BCA Assessment Report

Burrows Road – Multi-Level Industrial Facility
1-3 Burrows Road, Alexandria

Revision 11

11th December 2024

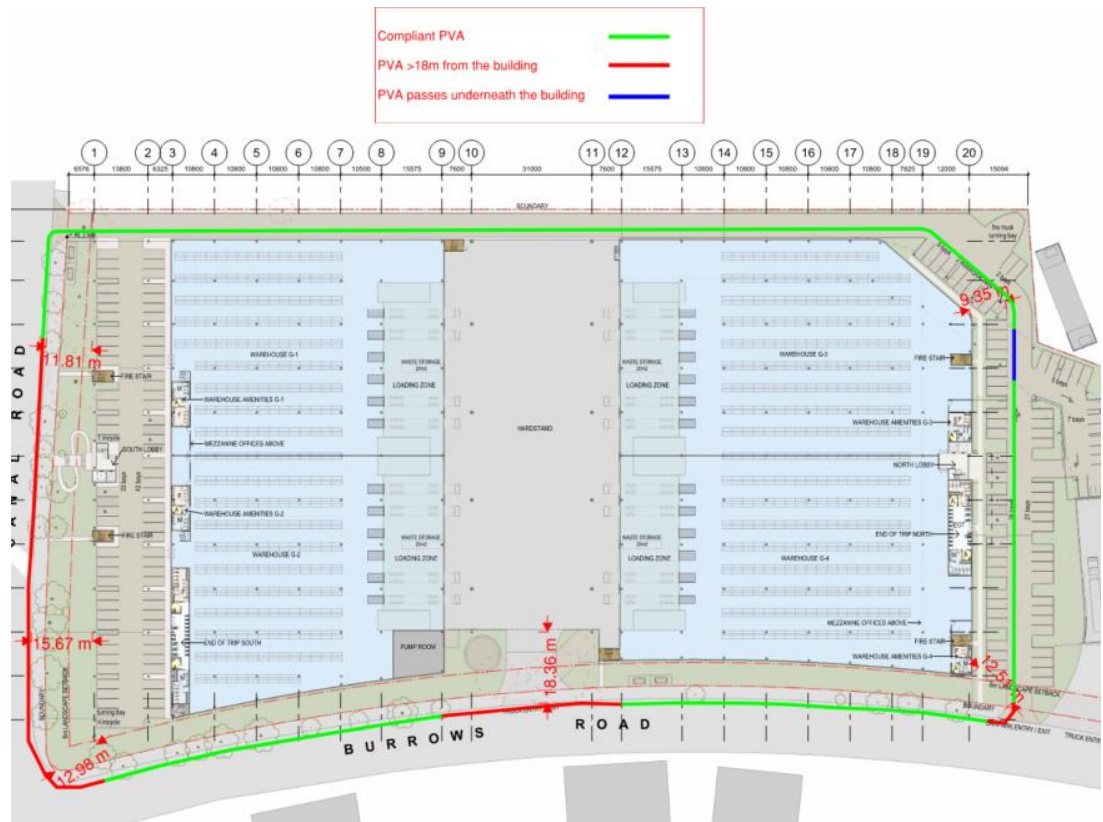
3.	C3D4 / C3D5	Perimeter Vehicular Access is non-compliant with C3D5 for the proposed Large Isolated Building. Refer to mark up in the clause for non-compliance locations.

C3D5	Requirements for Open Spaces and Vehicular Access: Open space and vehicular access required by C3D4 must comply with the requirements of sub-clauses (a) & (b) of this Part whereby they must be 6m wide within 18m of the external walls of the building and of a suitable bearing capacity and unobstructed height to permit the operation and passage of FRNSW vehicles. Comment: Refer to markup below of approximate locations where non-compliant perimeter vehicular access is provided and will be subject to a fire engineered Performance Solution. Location of the edge of the road and line of building over is to be clearly nominated to confirm these distances.
